**Addendum No.:** 4

**Bid#:** 307-00-17-14-2

**Project Name:** Wax Wing Canal Improvements

**Addendum No.:** 2

1. Drawing.pdf

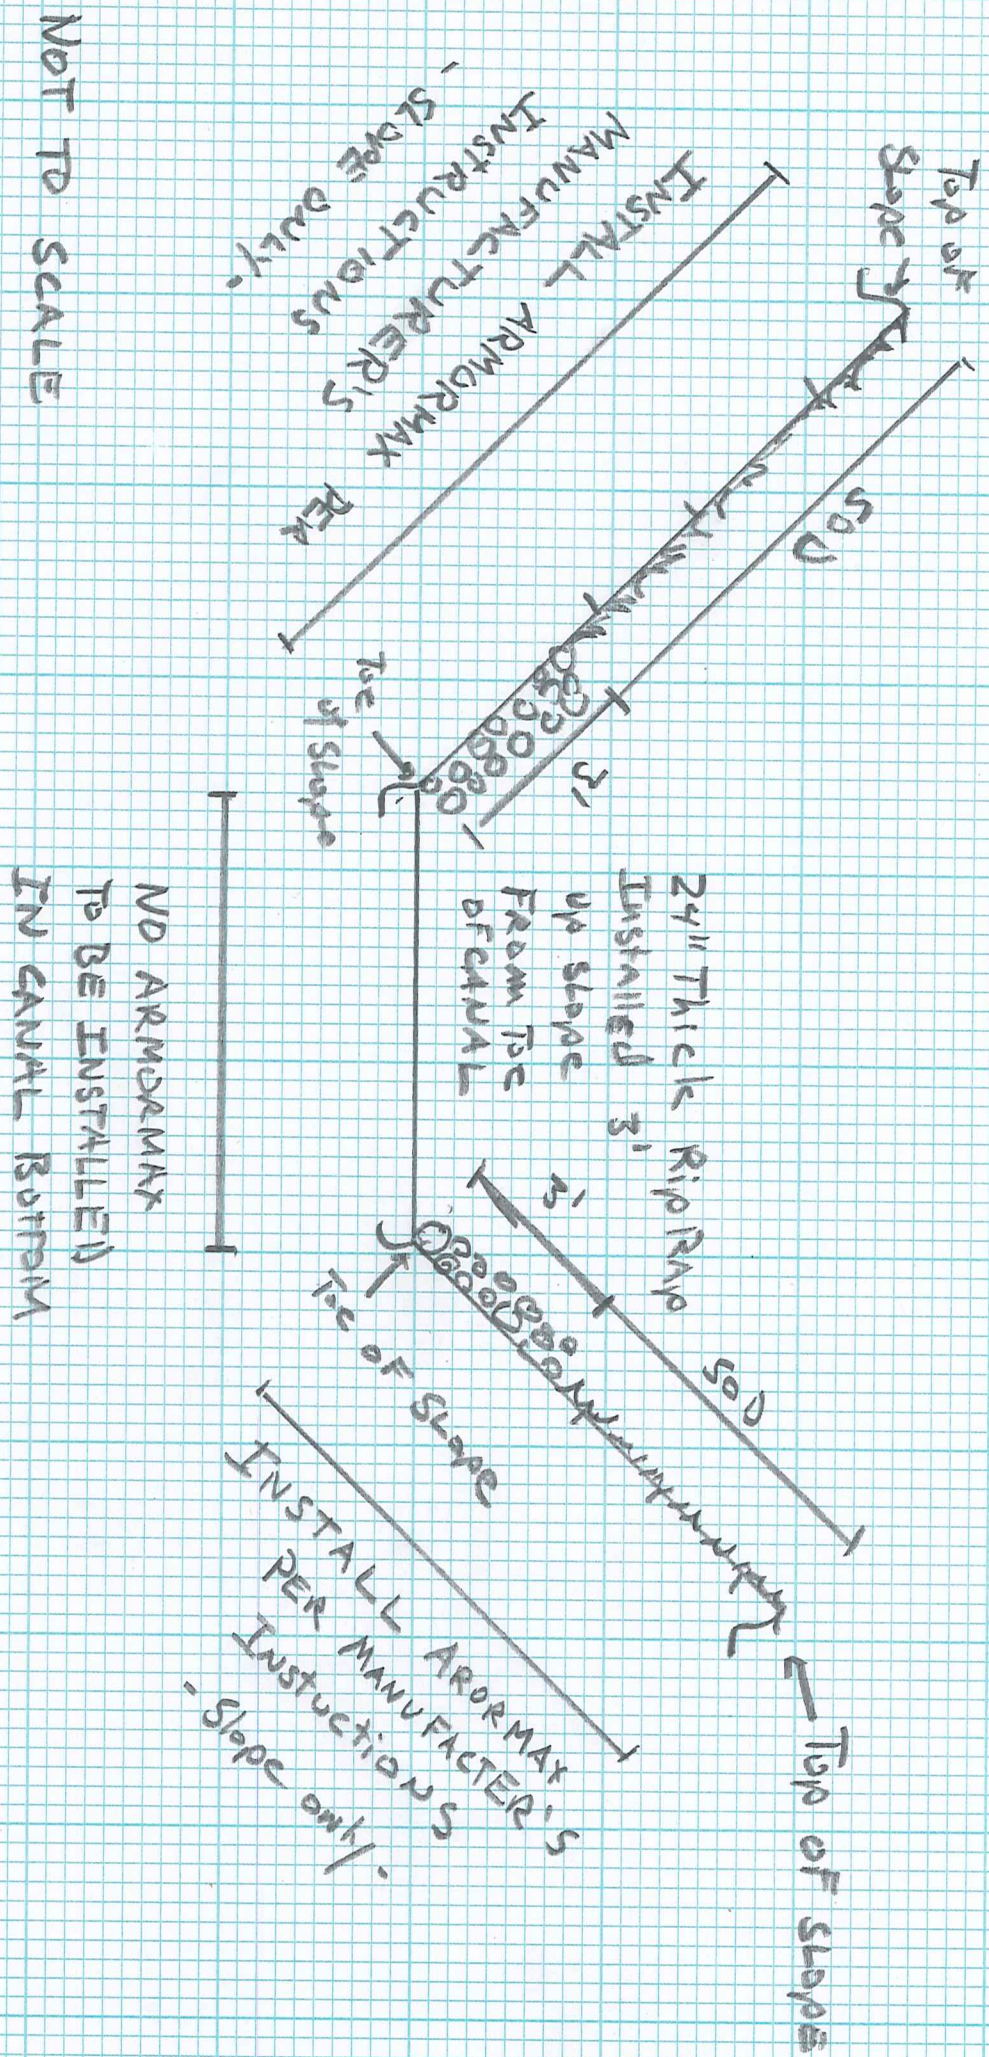
1. Please see the attached drawing that includes the location of where the Armormax, or approved equal, needs to be installed. (Attached)

**Question #1:** Please provide clear detail of of where armormax System is to be located on ditch. On Sides and on bottom?

**Answer #1:** Please see the attached sketch. Armormax, or approved equal, is to be installed on the side slopes of the canal only. No Armormax, or approved equal, is to be installed in the canal bottom.
